# RVS50-D-02

rev:12-1-2021

## Build-To Sheet

RVP-225-MU-04  
box  
(shown closed and sealed)

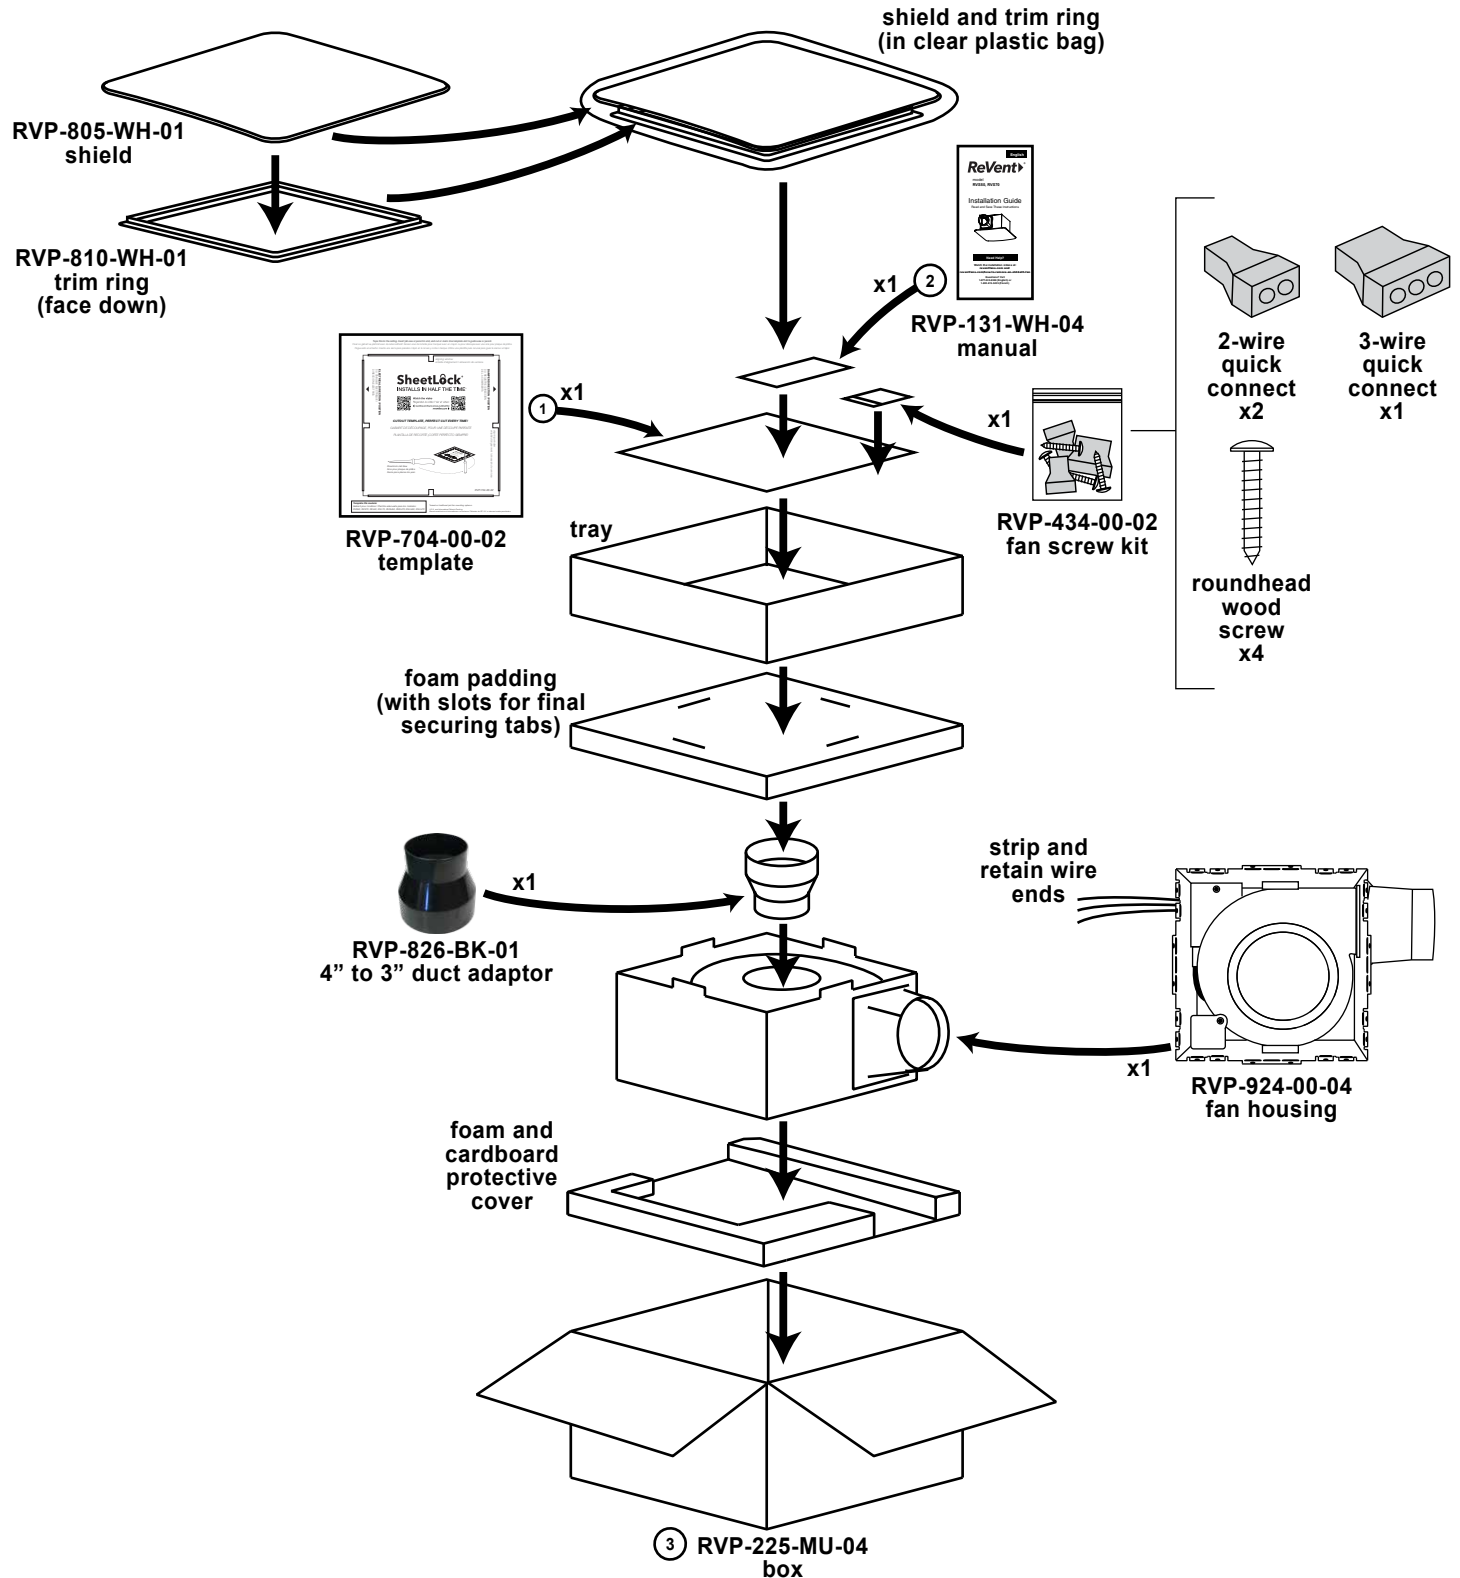
9/20/2021	RVP-131-WH-03	Updated manual (corrected performance specs [Sone, W, CFM] to match HVI report and removed HVI *) (page 1)
	RVP-225-MU-02	Updated box (corrected performance specs [Sone, W, CFM] to match HVI report and removed HVI *) (page 1-2)
	RVP-924-00-02	Updated fan laser printing (corrected performance specs [Sone, W, CFM] to match HVI/UL reports) (page 3)
9/24/2021	RVP-131-WH-03	Updated manual (R40 changed to R-50) (page 1)
	RVP-225-MU-02	Updated box (R40 changed to R-50) (page 1-2)
10/27/2021	RVP-225-MU-02	Updated box (added patent claim) (page 1-2)
11/1/2021	RVP-131-WH-04	Manual part # updated from -03 to -04 (page 1)
	RVP-434-00-02	Screw kit part # updated from -01 to -02 (page 1)
	RVP-225-MU-03	Updated box (added patent claim, added box part# to bottom of box) (page 1-2)
	RVP-924-00-03	Updated fan laser printing (changed "PRC" to "China") (page 3)
11/24/2021	RVP-225-MU-04	Corrected box (changed "x" to "to" on cm Duct dimensions on side of box) (page 1-2)

## Label Placement (bottom of motor)

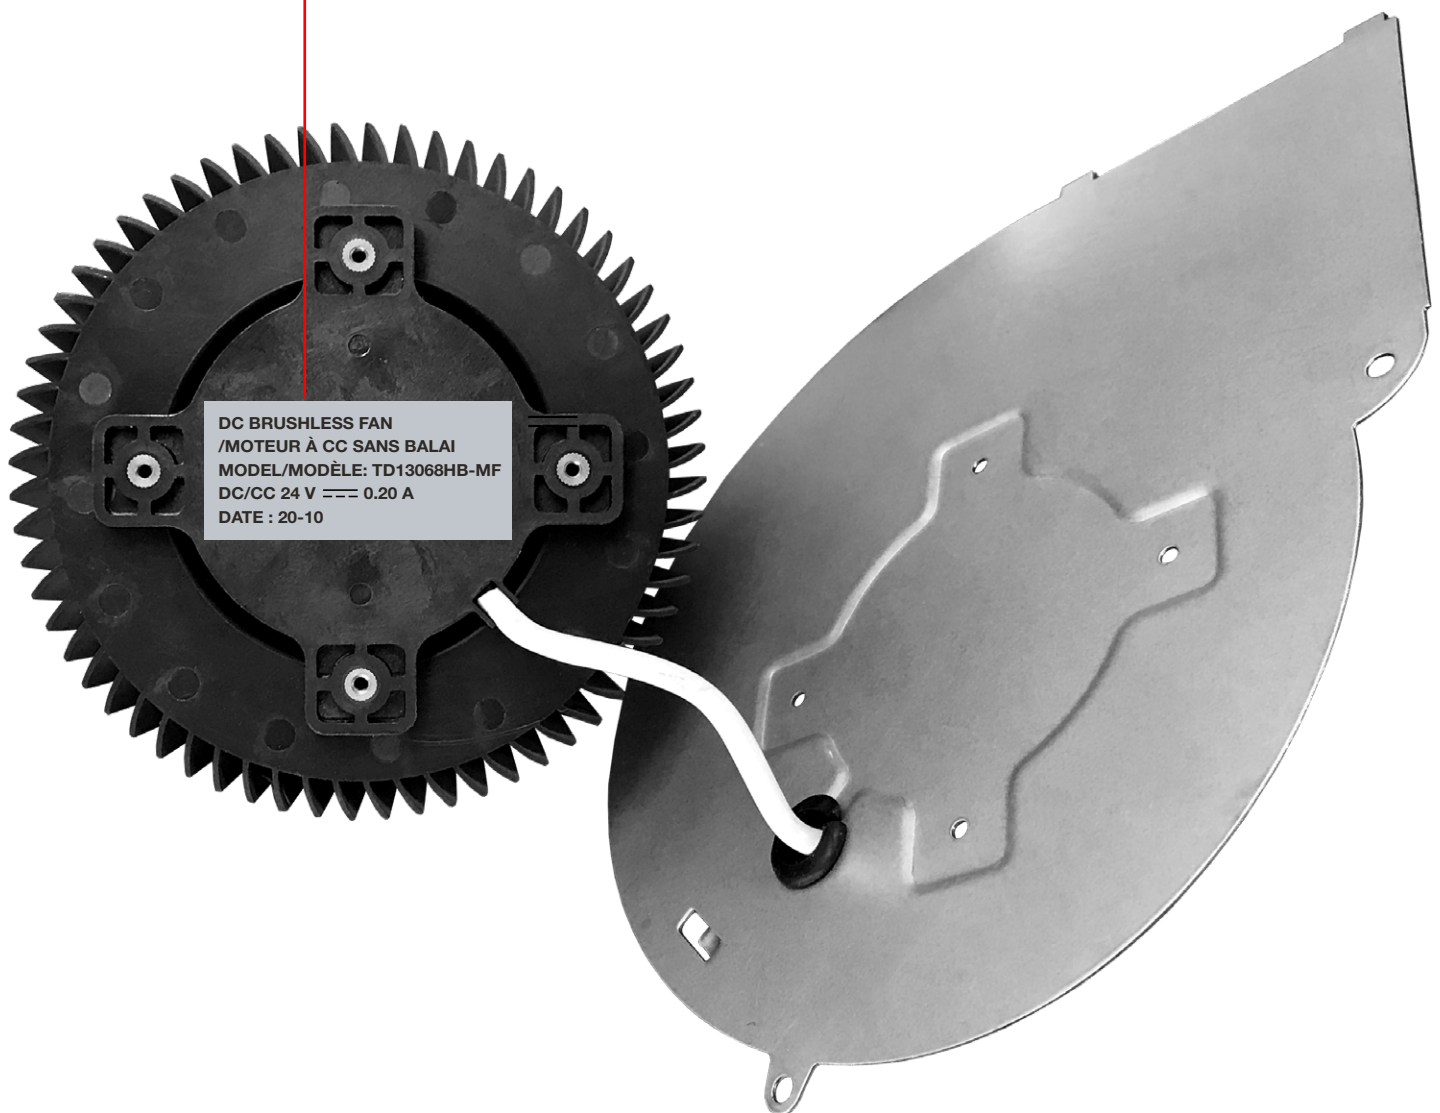
12/1/2021	RVP-924-00-04	Updated fan motor label (added French to make it generic with DC models) (page 4)

DC BRUSHLESS FAN  
/MOTEUR À CC SANS BALAI  
MODEL/MODÈLE: TD13068HB-MF  
DC/CC 24 V  $\equiv$  0.20 A  
DATE : 20-10
